Standardized Information for Process/Product Change Notification (PCN)

1. PCN basic data		
1.1 Company		YAGEO Group No. 16, West. 3rd St., Nanzi Dist., Kaohsiung (N.T.I.P.) 811626, Taiwan
1.2 PCN No.	EBR-26002	
1.3 Title of PCN	Material Change of CC / X7R / 0603 / 6.3V to 16V / 2.2uF, CC / X5R / 0603 / 6.3V to 25V / 2.2uF	
1.4 Product Category	MLCC CC X5R / X7R Series	
1.5 Issue date	23-Mar-26

Construction
25-221-25

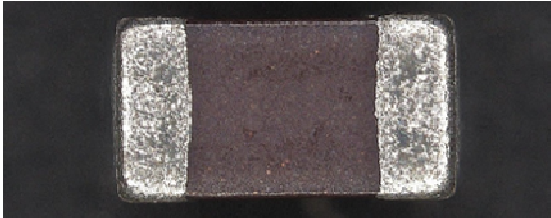
3. Changes			
No.	3.0 Ident	3.1 Category	3.2 Type of change
#1	PAS-CER-MA-03	Change of material composition - Dielectric	Change from ceramic A to ceramic B
#2	PAS-CER-DE-05	Changes of inner construction - Layer Thickness	Ceramic layer thickness changes from 53/55um to 75um
#3	PAS-CER-DE-06	Changes of inner construction - Number of Layers	See Appendix

4. Description of Change		
	Old	New
Change #1	Ceramic A	Ceramic B
Change #2	Ceramic thickness : 53/55um	Ceramic thickness: 75um
Change #3		
4.1 Anticipated impact on form, fit, function, reliability or processability?

9-174-9
